Andrew Jackson of 2 Ashbrook Cottages Stevenage Road Hitchin Hertfordshire SG4 7JY
(Objects)

26/00006/FP

Erection of 50no. residential dwellings (including affordable) with public open space, associated parking, landscaping and access

Red line boundary unclear and green arrow showing through traffic

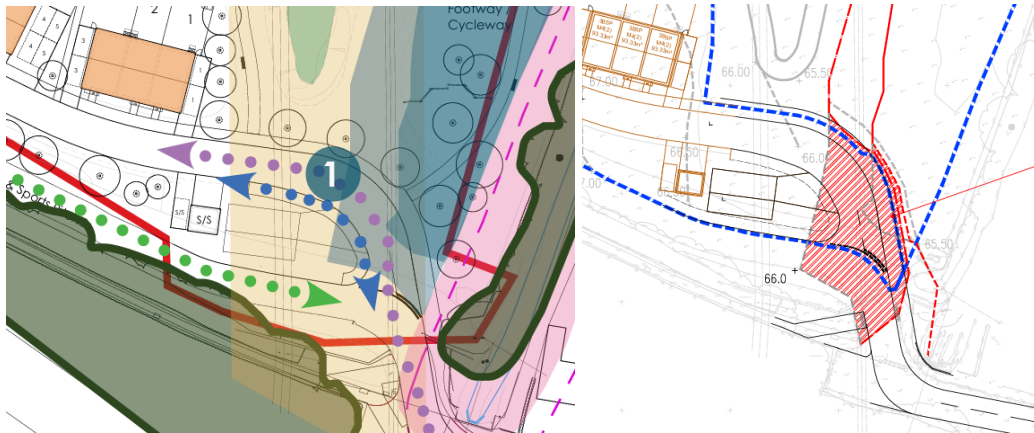
There are a number of inconsistencies with the site boundary in the traffic analysis. It is missing on many of the drawings and in some images it is showing the access road as a through road when it is not. It is unclear if the proposed red line boundary does or does not

include the area between the existing access road and entrance to the development. This is the **ONLY** access to the proposal and it should be clear who and to what owner this space belongs to and if it is part of this application or not.

Current access shown on proposal as an open road

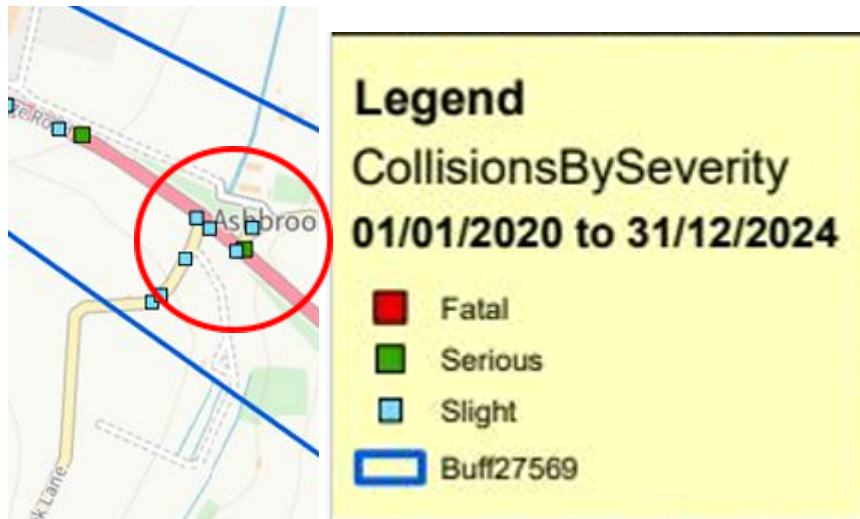
The current access is not a through road and does not seem to be created in the proposal although some of the plans do show it as a through road. This is unclear in the proposal if one of these entrances will be incorporated into the site or if the school will move the gate past the proposal. The location of this gate is key for refuge and fire access, highlighted in point

Crashes highlighted in the traffic plan

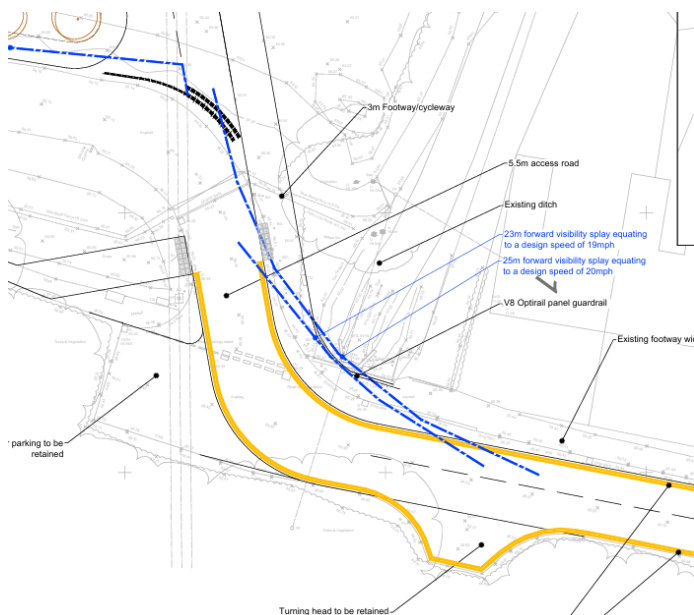
The travel plan highlights the current issues with traffic collisions at this junction. Just at the direct access to the site and the two junctions to get to it, there have been 5 collisions in the years 2020-2024. This is due to the speed and general bad design of the junctions which would only be exacerbated by the proposal rather than remedied.

Traffic plan showing poor visibility at the access to the site and not showing a red line boundary

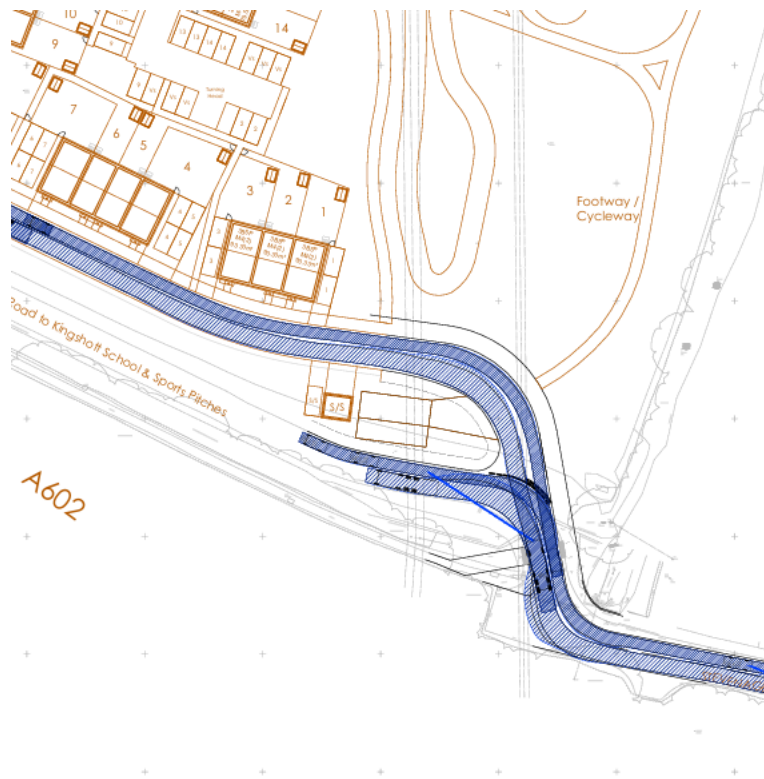
The traffic consultant highlights the poor visibility of the junction where visibility splays would not work at 20mph unless the council maintain the brook vegetation. They instead suggest acceptable visibility splays at 19mph which is not a possible speed limit.
